ADDITIONS AND RENOVATIONS TO NORTHSIDE HIGH SCHOOL

REVISIONS	NUMBER	DATE
COUNTY REVIEW	1	5/25/07
CO. REVIEW AND VE REV	2	8/17/07
COUNTY REVIEW	3	8/28/07

PROFILES - STORM DRAIN

C-2.4

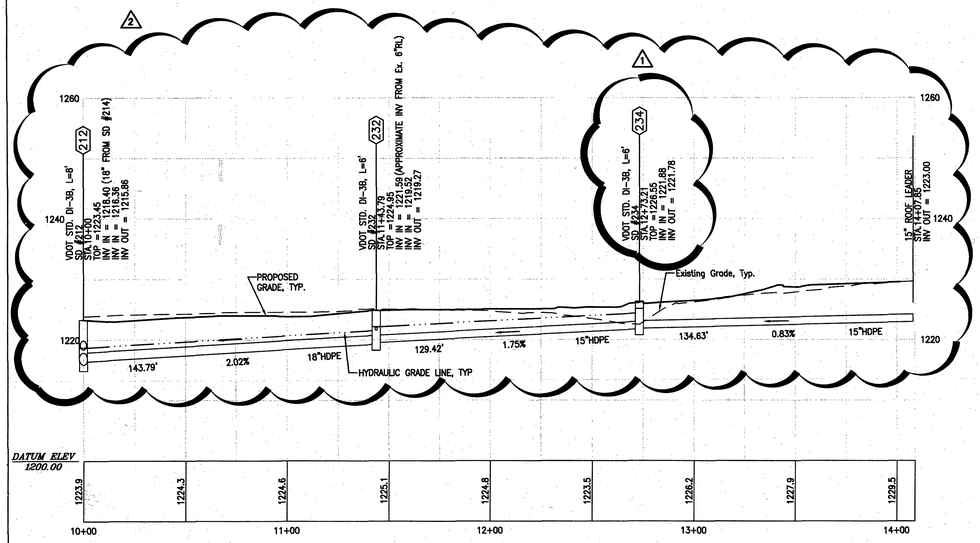
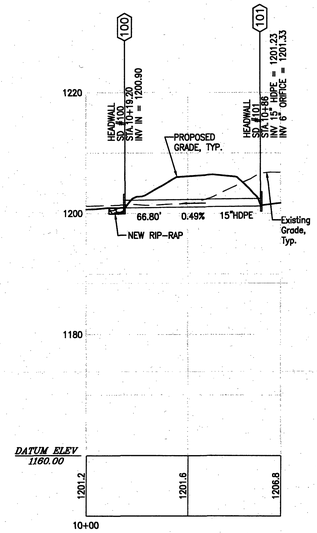
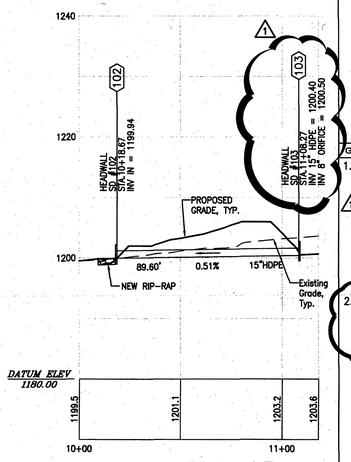
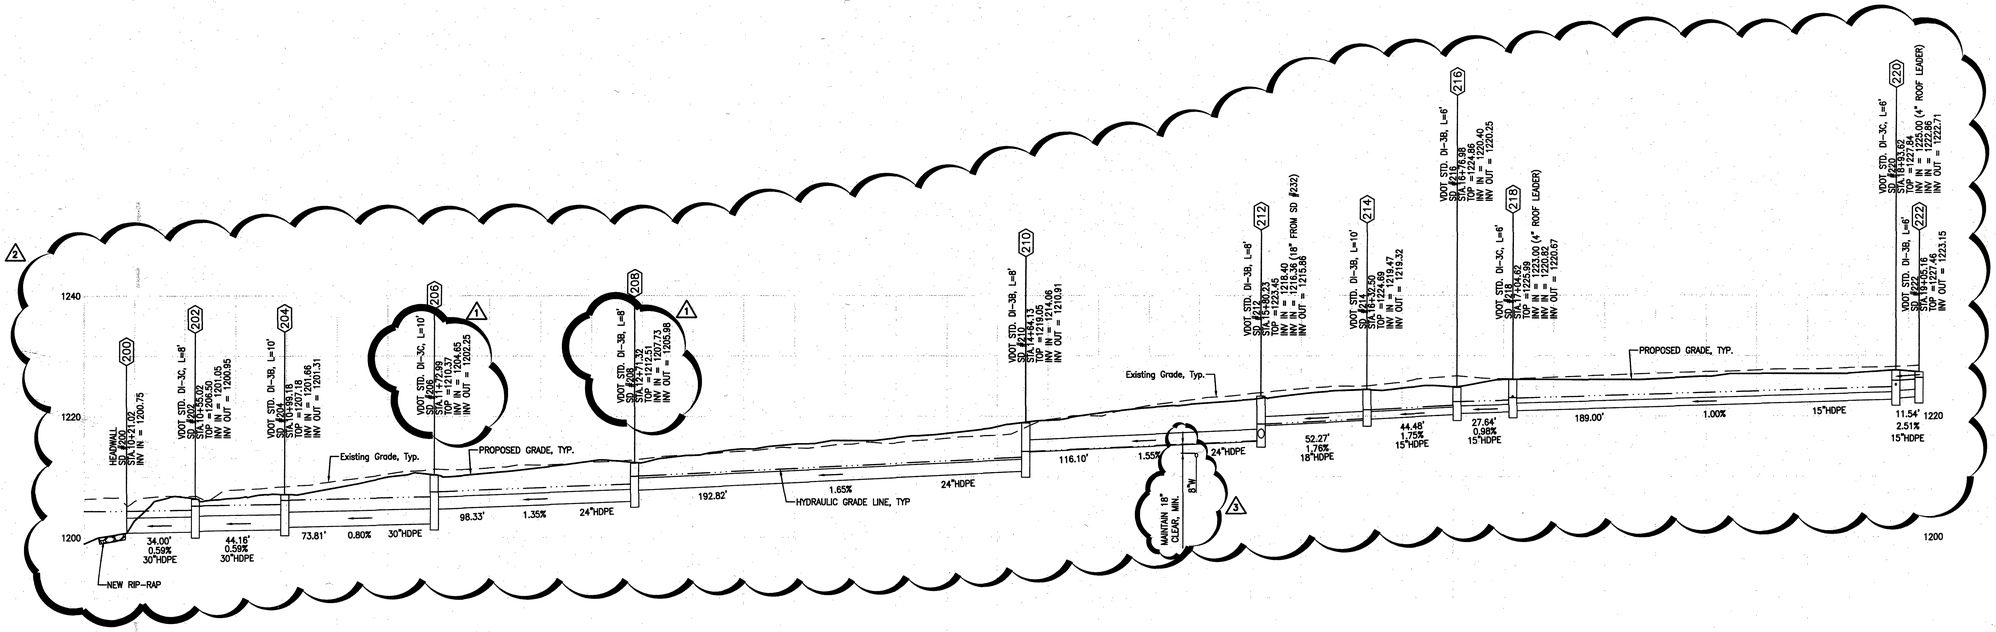
REVISION #2 CHANGES:
ALL STORM DRAIN PIPE MATERIAL HAS BEEN CHANGED TO HDPE. ADDITIONALLY, STORM DRAIN TOP ELEVATIONS HAVE BEEN REVISED DUE TO THE ELIMINATION OF THE GUTTERS (PHASE I).

1. THE ANNOTATION OF ALL STORM DRAIN STRUCTURES HAVE CHANGED FROM "RIM" TO "TOP" ELEVATIONS. IN THE CASE OF CURB INLETS, "TOP" INDICATES THE TOP OF THE STRUCTURE/TOP OF CURB ELEVATION. IN THE CASE OF DROP INLETS, THE "TOP" ELEVATION INDICATES THE TOP OF GRATE ELEVATION.

2. STORM DRAIN PIPING MATERIAL SHALL BE CORRUGATED HIGH-DENSITY POLYETHYLENE (HDPE). COVER AND INSTALLATION SHALL COMPLY WITH THE COUNTY OF ROANOKE INSPECTION SPECIFICATIONS FOR HDPE PIPE.
